## CUSTOMER SERVICE BULLETIN

April 29, 1966

NCX-5  
CSB 66-1

#### DRIVE FALLS OFF AT HIGH END---15 METERS

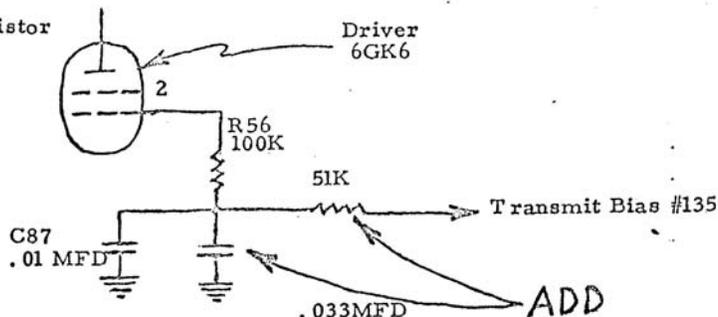
L-13 and associated wiring sets up a stray resonant trap which acts as a suck-out on 15 meters.

The following steps should be taken to eliminate this condition:

1. Disconnect the white coax lead (labelled #11), at 10 o'clock on the switch wafer section (S1-G) located between power amplifier cage and crystal mixer shield.
2. Reconnect the coax to the fourth (4th) unused terminal on S1-G, counting clockwise from the original terminal. This unused terminal is located at approximately 2 o'clock.
3. Connect a 100-ohm 1/2 watt resistor between the two terminals of S1-G mentioned above.
